EXHIBIT 9  
Page 1 of 1

| Name                                                                                                 | BATTERY DOORELL  |
| REV                                                                                                  | 315031-02-B1 (S) |

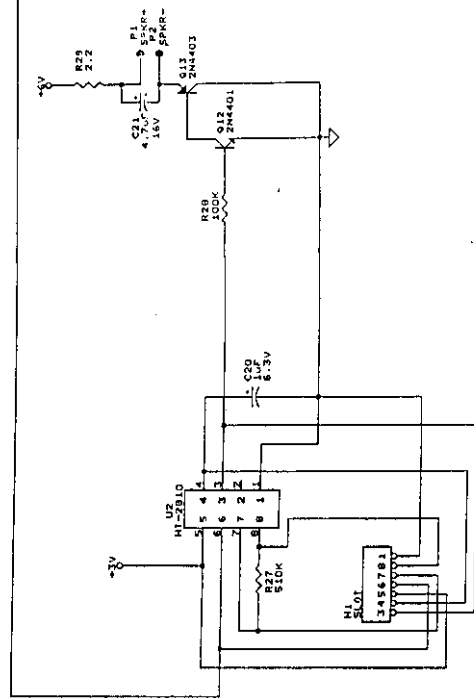
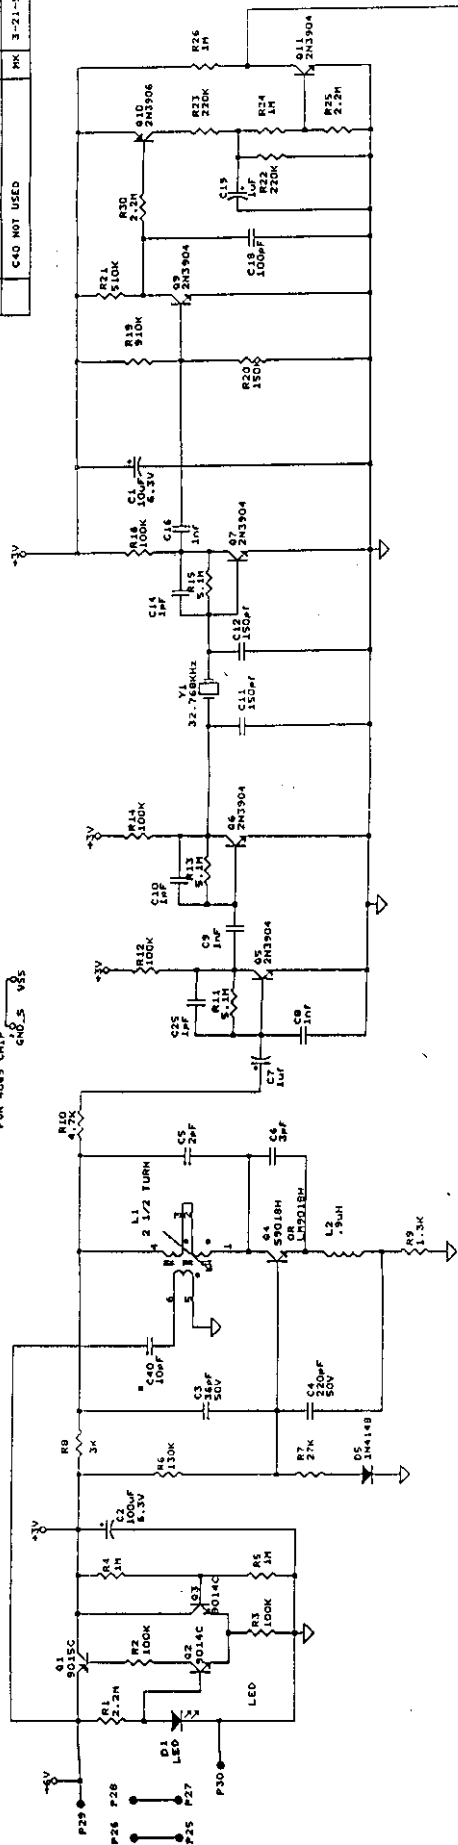
| SYM | REVISION / ECM                                                                     | BY | DATE        |
|-----|------------------------------------------------------------------------------------|----|-------------|
| R0  | ECM 485, BOARD LAYOUT<br>REVISED TO USE IM0                                        |    |             |
|     | DIFFERENT TYPES OF MUSIC                                                           |    |             |
|     | ICS .                                                                              |    | HK 12-07-95 |
| R1  | ECM 504, L1 CHANGE, C5 HAS<br>1µF IS NON 2µF, C6 HAS<br>2µF IS NON 3µF, HOLE ADDED |    |             |
|     | C40 NOT USED                                                                       |    | HK 3-21-96  |

| B1 | ECN 506, L1 CHANGE, C5 WAS 1pF   |    |          | NAME                                                                                                                                                         |    |       |         |
|    | IS NOW 2pF. C6 WAS 2pF IS NOW    |    |          | BATTERY DOORBELL                                                                                                                                             |    |       |         |
|    | 3pF, HOLE ADDED, C49 NOT USED    | MK | 3-21-96  | DRAWN                                                                                                                                                        | MR | DATE  | 3-21-96 |
| B1 | ECN 481, NEW E, P, L, C, D, T, T |    |          | DRAWN                                                                                                                                                        |    |       |         |
|    | ALLOW THE USE OF CAPTIVE         |    |          | B1(A)                                                                                                                                                        |    |       |         |
